Intel® Pentium® 4 Processor in 478-pin Package and Intel® 845 Chipset Platform for DDR

Design Guide Update

March 2004

Document Number: **298595-003**

1. **Replaced: Replace Figure 139, Intel® 845 Chipset Platform Using DDR System Memory Power Delivery Map**

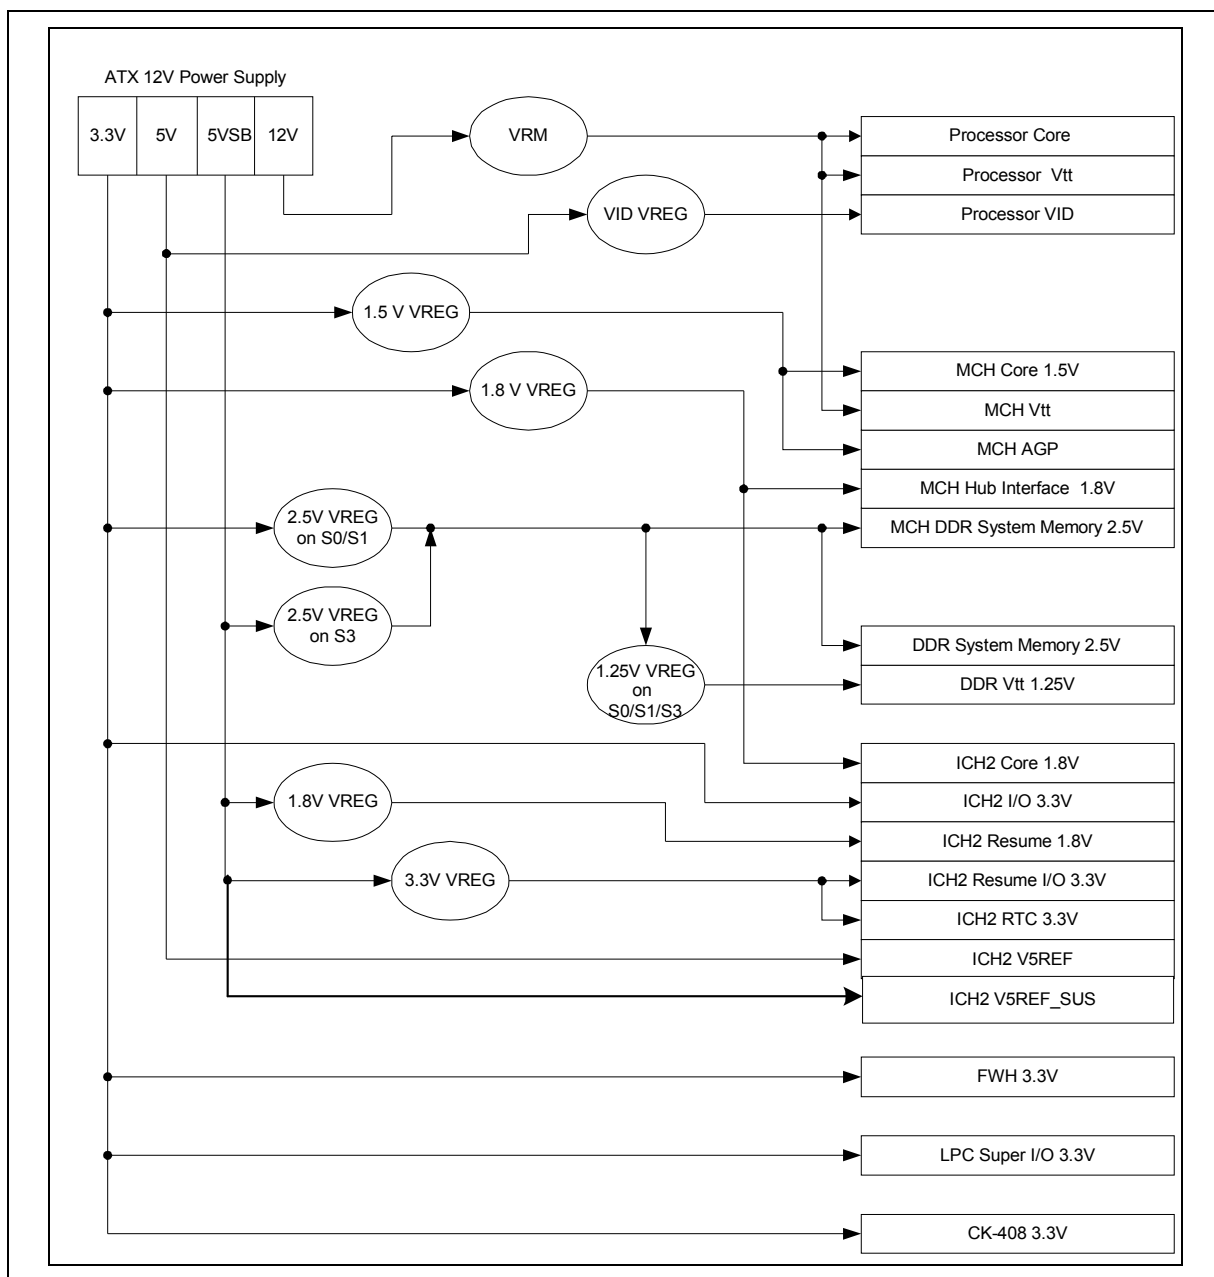
Figure 139, Intel® 845 Chipset Platform Using DDR System Memory Power Delivery Map, in Section 12.2, has two changes in the ICH2 section:

One ICH2 power plane is added to it. This added ICH2 power plane is “ICH2 V5REF_SUS”. This power plane has always existed in the ICH2. It is not new. This addition to the Power Delivery Map simply shows this ICH2 plane.

The block labeled “ICH2 5 V” is renamed to “ICH2 V5REF”.

These two changes above also reflect the actual pin names on the ICH2.

A third change is that the two, 2.5 V VREG voltage regulators have corrections to the supported system power states (S0, S1, S2, etc.).

A forth change is that the supported system power states for the 1.25 V VREG voltage regulator have been moved inside the ellipse.

Figure 139 is replaced with the following new Power Delivery Map:

Figure 1. Top Signal Layer before the Ground Fill Near the I/O Area

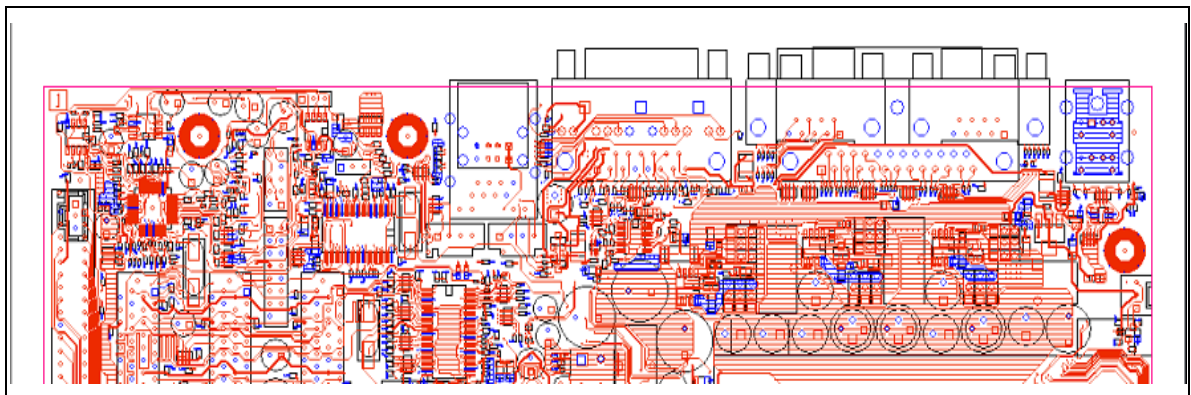
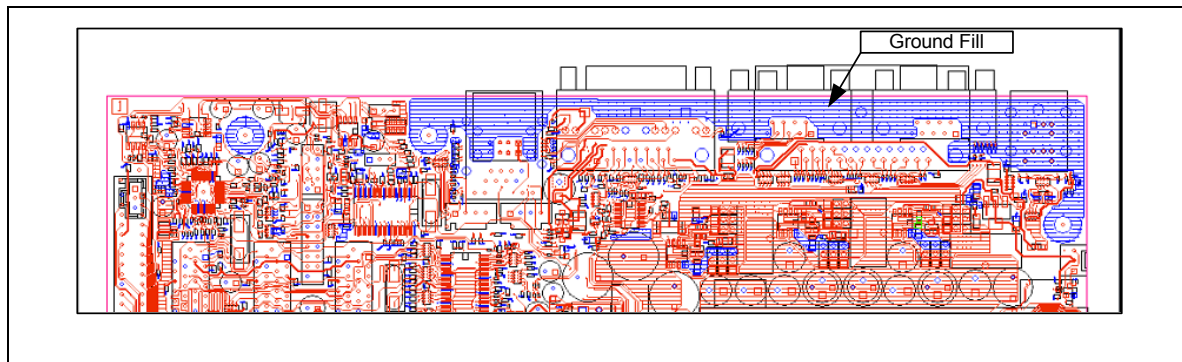
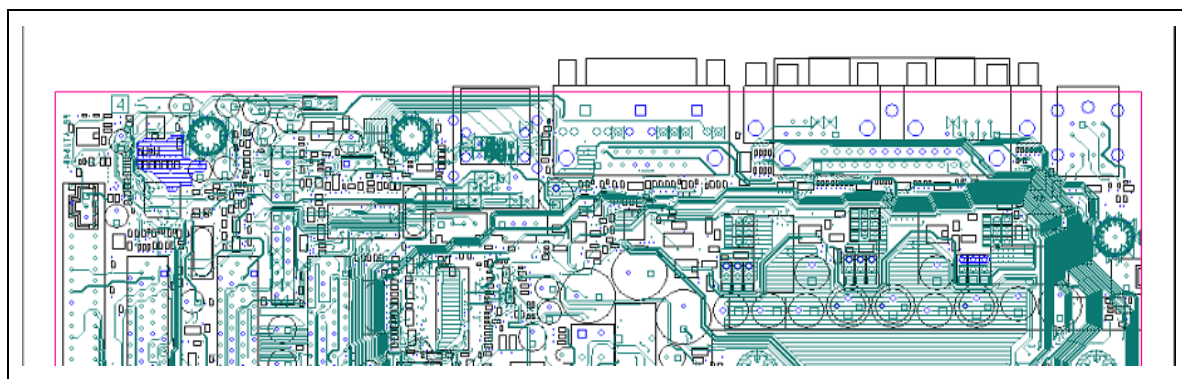
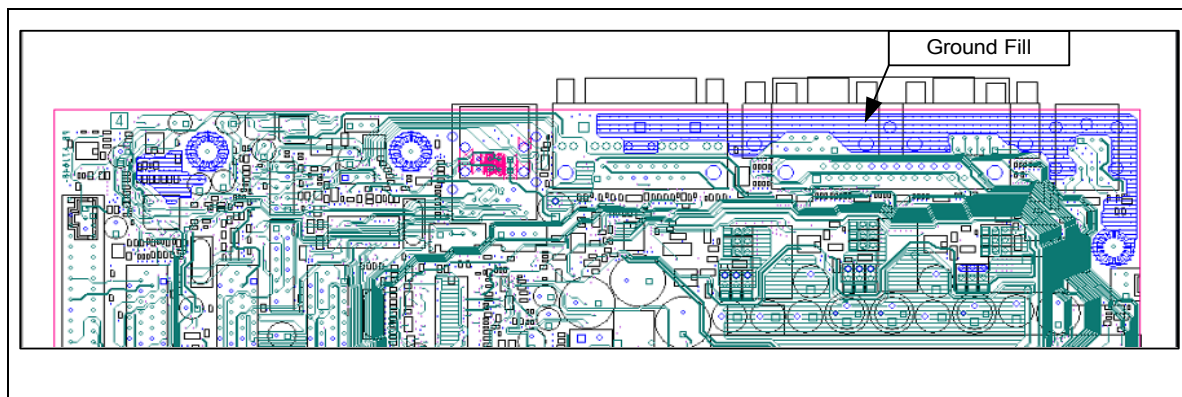
Intel recommends that the I/O area on the top and bottom signal layers of a 4-layer motherboard near the I/O back panel be filled with a ground fill as shown in Figures 1-4. In addition, a ground fill cutout should be placed on the Vcc layer in the area where the ground fill is done on the top and bottom layers. Intel recommends filling the I/O area as much as possible without effecting the signal routing. The board designer should fill the entire I/O area along the board edge.

The spacing from the ground fill to other shapes/traces should be at least 20 mils. It is recommended that these ground fill areas be connected to two chassis mounting holes (as seen in Figure 2). This will allow ESD current to travel to the chassis instead of the board. Ground stitching vias should be placed throughout the entire ground fill if possible. It is important that the vias are placed along the board edge. Ground stitching vias for the ground fill should be 100–150 mils apart or less.

- Fill the I/O area with the ground fill in all layers including signal layers whenever possible.
- Extend the ground fill along the entire back I/O area.
- Connect the ground fill to mounting holes.
- Place stitching vias 100-150 mils apart in the entire ground fill.
